ORDERS UNDER SECTION 96 (2) OF ACT III OF 1910.

With reference to his application dated 10th Dec 1913.
 Mr. Amirul Haq is informed
 that the plan submitted by him for building a house
 on plot No. 26 Survey Sheet 266
 situate in Market Street
 Quarter, is approved, and permission to build in accordance therewith is
 granted. The building to be erected subject to the Byelaws and Rules of the
 Municipality.

In continuation of this office No.E.8471 dated 20/22nd ultimo, Mr. Mahomed is informed that the proposed building covers one plot and a part of another plot No.56 & 73, A-16, Market quarter. The width of the street opposite plot No. 56 does not allow of a three storied house being erected. We must submit a proper block plan with his application.

PLAN SHOWING PROPOSED BUILDING
ON PLOT No 56 MARKET Qr KARACHI.
SCALE 8 FT TO ONE INCH

MARKET Q^B₁₇SHEET N^o. A. 16.

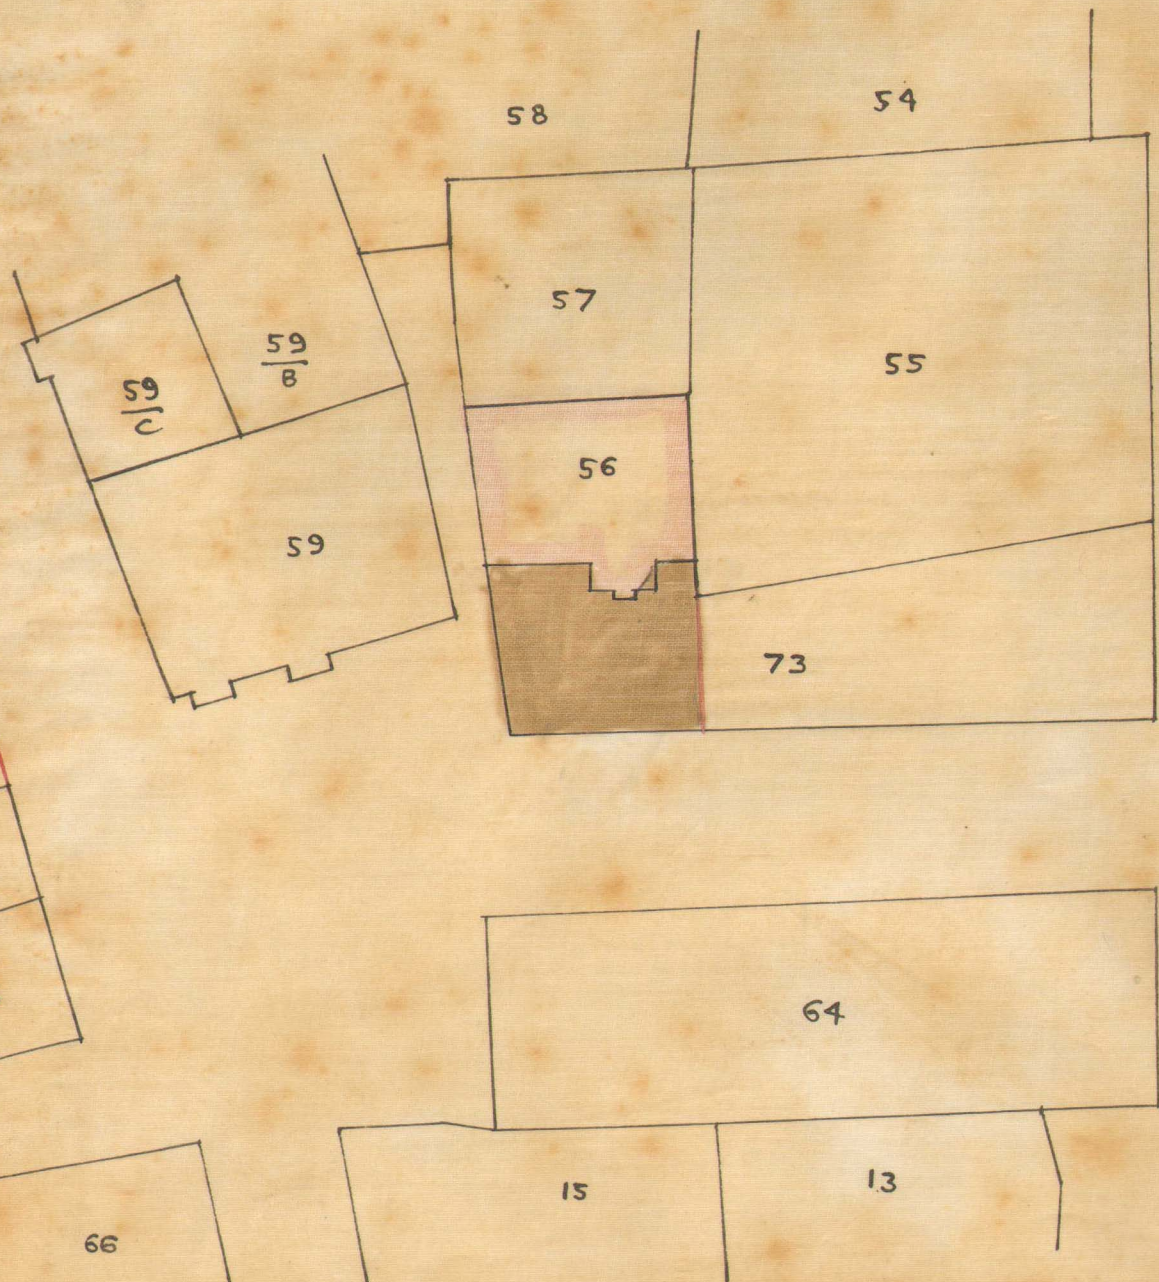
With reference to the attached Correspondence re the house ^{to be} rebuilt on plot no 56 A 16 Market Quater, I beg to report that the applicant proposes to build a building on plot no 56 and portion of plot no 73 A 16. as the height of the building ~~to~~ on the plots to be regulated according to the width of the street, I request to know whether in this case how the height to be taken as amalgamated one or separate one.

In form applicant that the ^{proposed} building covers our plot & part of another viz plots 56 & 73 A 16 Market Qr. The width of the street opp. plot no. 56 does not allow of a 3 story building being erected. He must submit a proper block plan with his application. The plan is disapproved.
V. 14/1/14

Surveyor
alignments should be taken from plot 59
when an application for building is
made, in these circumstances
the plan for building on plot no.
56 may be passed.

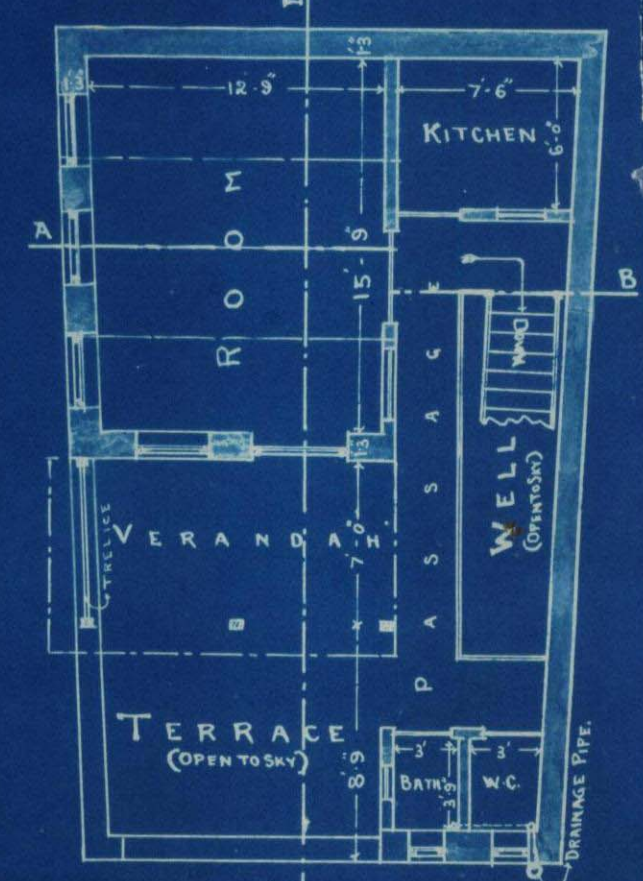
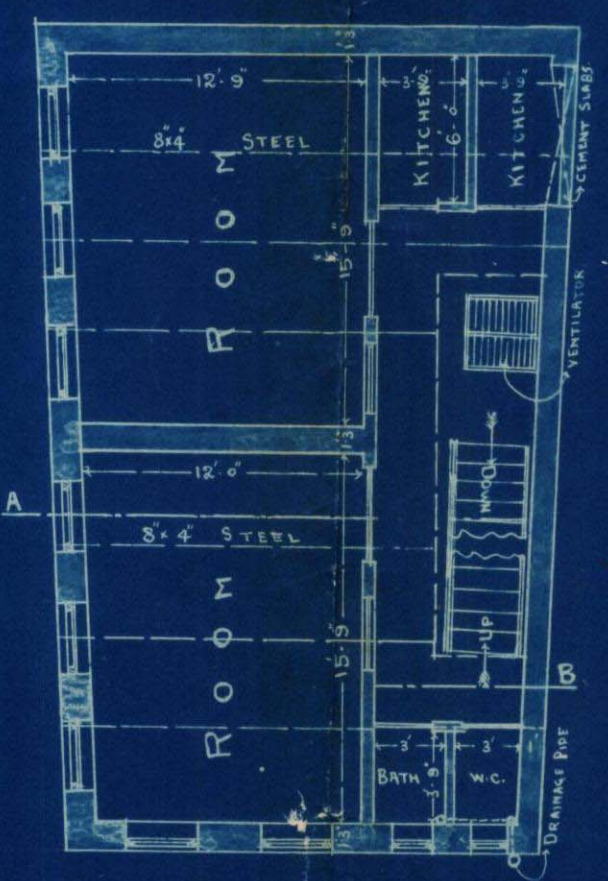
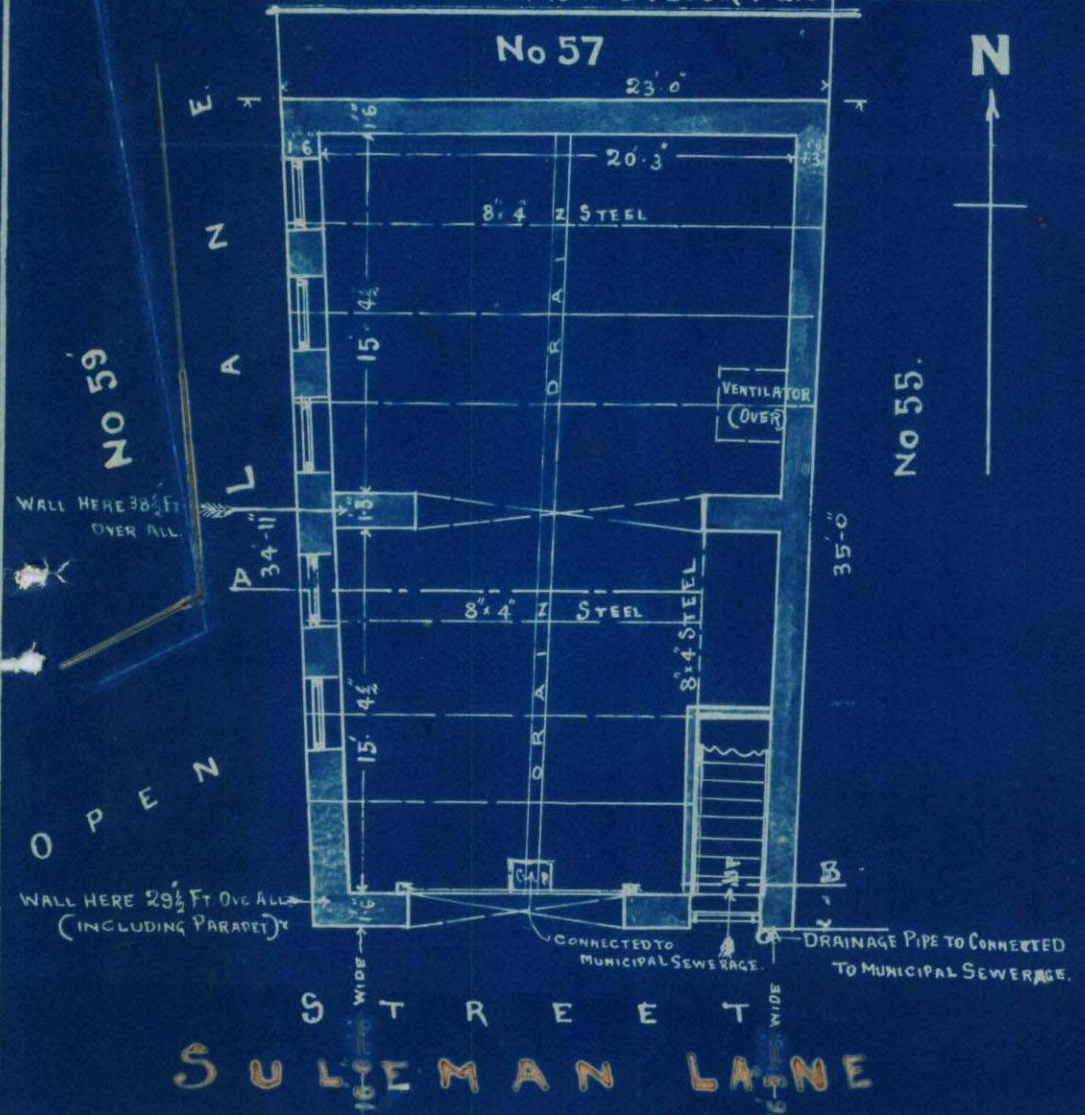
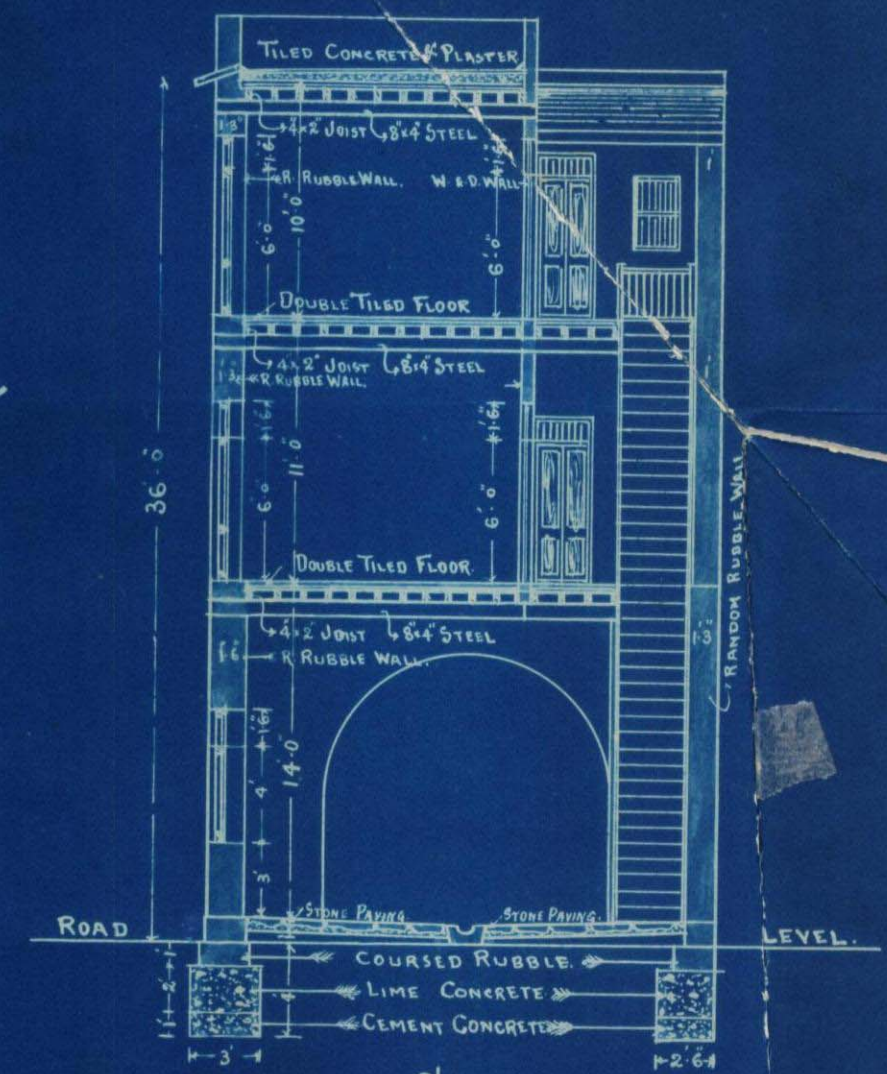
Ref. of the accm.
appl. with plan for erecting
house on plot no 56, A16
No. 1000 gr. I beg to report
that the a block^{plan} must
be separately shown as
complained by the No. -
This building includes a
portion of plot no 73
also which is not
shown in the plan. If
he wants to build on
plot no 56 only the
height as shown
cannot be allowed being
a small lane in
front.

L. Surryor inform
applicant that a proper
"block" plan must be
submitted. A drain
cannot be allowed
through the building.
The building as shown
occupies more than
one plot. There is
not sufficient space
for two kitchens on
this in the building.

Returned to the Engineer, Karachi Municipality, with the following remarks— *Upr does not know what is ground floor means etc, as the drain line runs through the centre of the building. There is no sufficient space for two kitchens to be built on 1st floor*

The plan is disapproved and returned for amendment.
